TECHNICAL BULLETIN

031

September 2023

CURRENT VITON
PLUNGER OIL SEALING

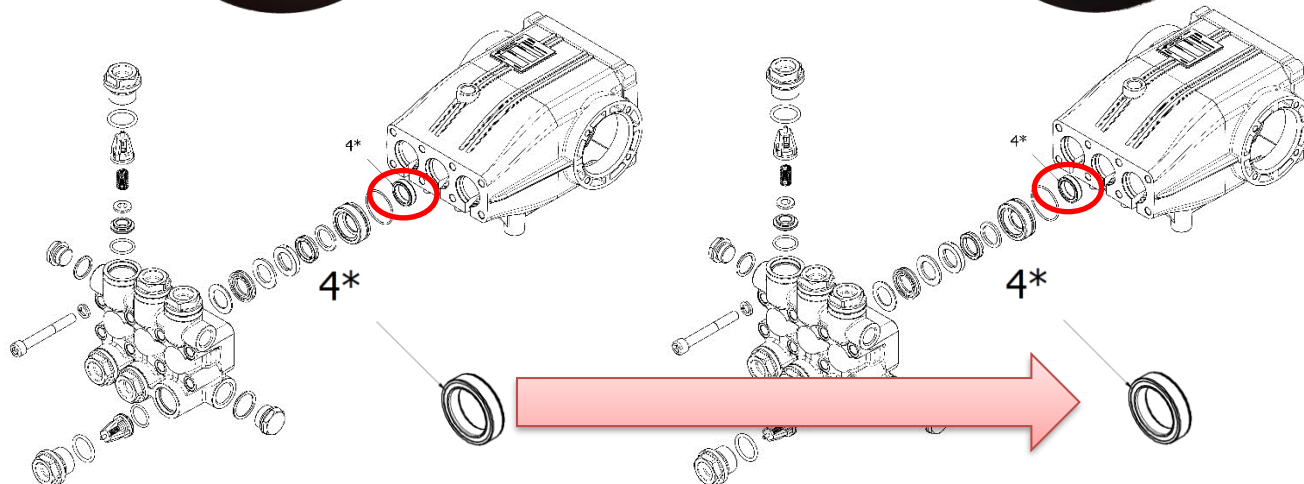
- Substituted plunger oil sealing in VITON with HNBR for pump series XLT-HT/XXT-HT/MXT-HT (up to 85° C) (on the position indicated ex.: 4).
- Both type of sealing **ARE INTERCHANGEABLE**.
- “Plunger oil sealing kit” will keep the same **code 1.905-545.0** but will contain the new HNBR.

CURRENT PLUNGER OIL SEALING XLT-HT/XXT-HT/MXT-HT		
POS.	DESCRIPTION	Q.TY
4	VITON PLUNGER OIL SEAL Ø20x30x7 TYPE A	3

NEW PLUNGER OIL SEALING XLT-HT/XXT-HT/MXT-HT		
POS.	DESCRIPTION	Q.TY
4	HNBR PLUNGER OIL SEAL Ø20x30x7 TYPE A	3

ATTUALE PARAOLIO
VITON

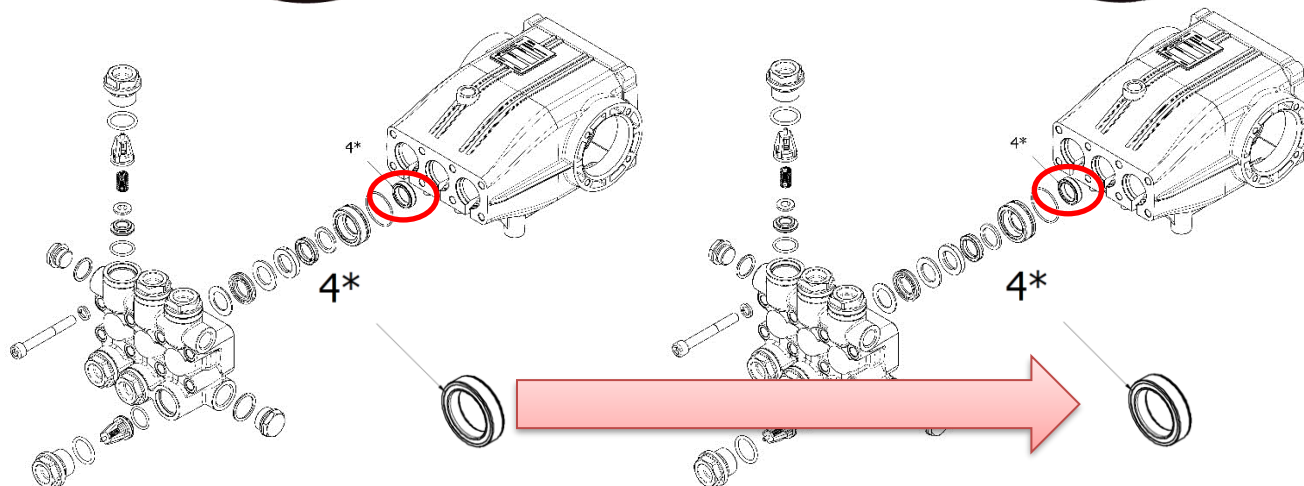
- Sostituzione dei paraoli in VITON con HNBR per le pompe XLT-HT/XXT-HT/MXT-HT (fino a 85° C di temperatura) (nella posizione indicata es.:4).
- I due paraoli **SONO INTERCAMBIABILI**.
- Il kit “Anelli tenuta olio asta” manterrà lo stesso **codice 1.905-545.0** ma conterrà i nuovi in HNBR.

ATTUALE PARAOLIO XLT-HT/XXT-HT/MXT-HT		
POS.	DESCRIZIONE	Q.TA'
4	ANELLO RADIALE Ø20x30x7 TIPO A VITON	3

NUOVO PARAOLIO XLT-HT/XXT-HT/MXT-HT		
POS.	DESCRIZIONE	Q.TA'
4	ANELLO RADIALE Ø20x30x7 TIPO A HNBR	3
